**UPDATE CHANGE NOTIFICATION # 20656**Generic Copy

**Issue Date:** 12-Nov-2014**TITLE:** Update notice of FPCN20656 to correct the assembly site and case outline information.**PROPOSED FIRST SHIP DATE:** 25-Dec-2014**AFFECTED CHANGE CATEGORY(S):** ON Semiconductor Assembly & Test**ADDITIONAL RELIABILITY DATA:**

Figure 1:

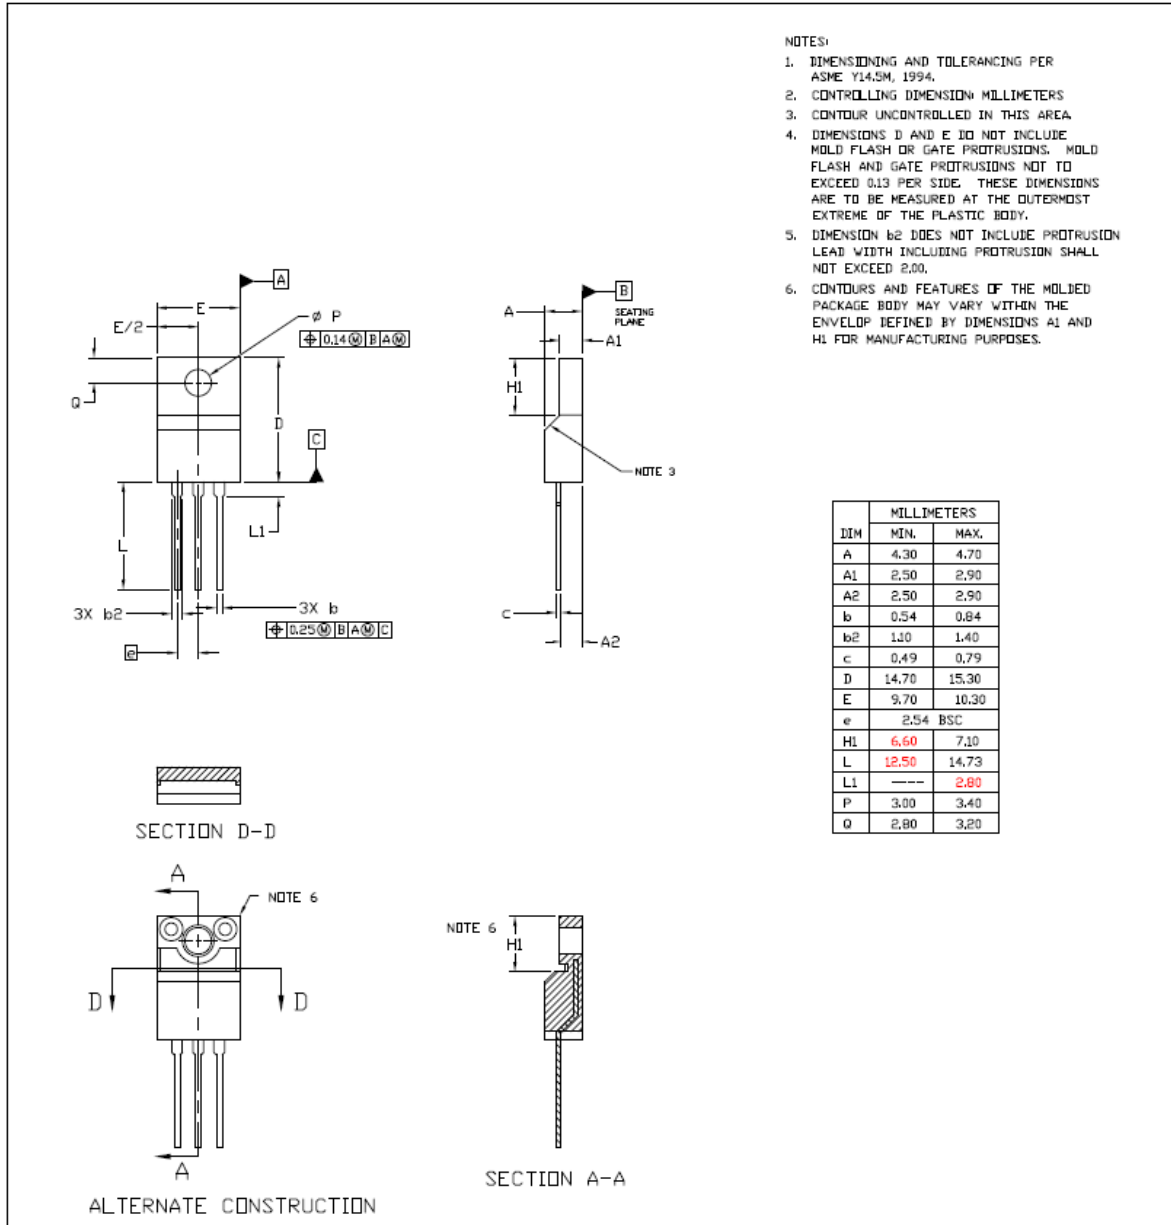
With this change the following devices will require a modification to the case outline as shown below in Figure 1.

MURF1620CTG  
MURHF860CTG  
MURF1660CTG  
NDF02N60ZH  
NDF03N60ZH  
NDF08N60ZH  
NDF04N60ZH  
NDF05N50ZH  
NDF06N60ZH  
NDF08N50ZH  
NDF10N60ZH  
NDF11N50ZH

Figure 2:

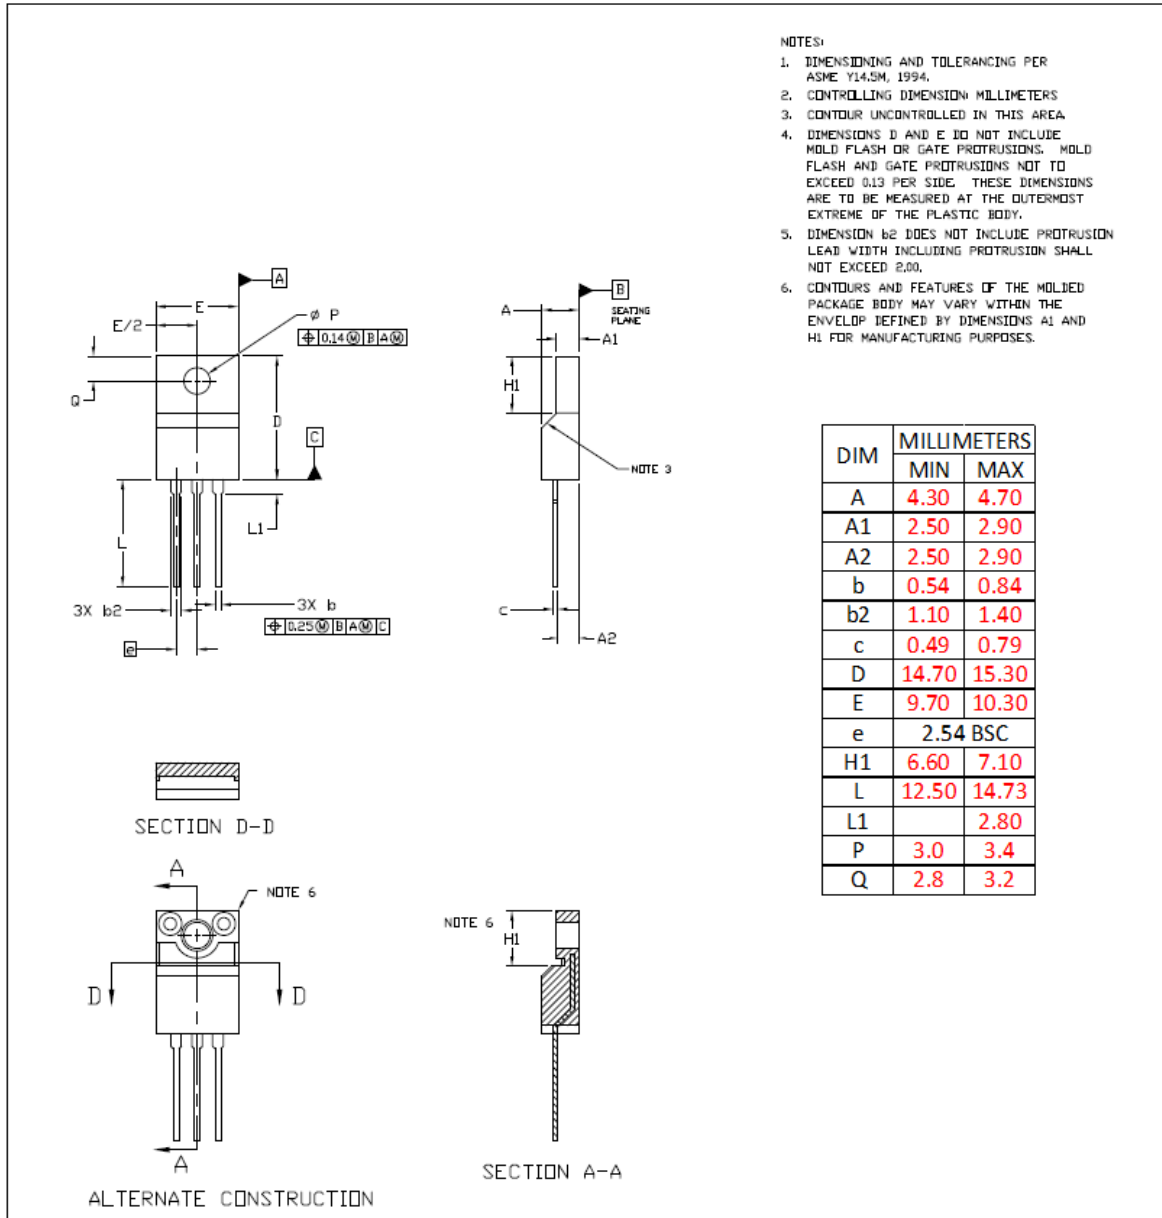
With this change the following devices will require a modification to the case outline as shown below in Figure 2.

NDF05N50ZG  
NDF08N50ZG  
NDF11N50ZG  
NDF02N60ZG  
NDF08N60ZG  
NDF10N60ZG  
NDF06N60ZG  
NDF03N60ZG  
NDF04N60ZG
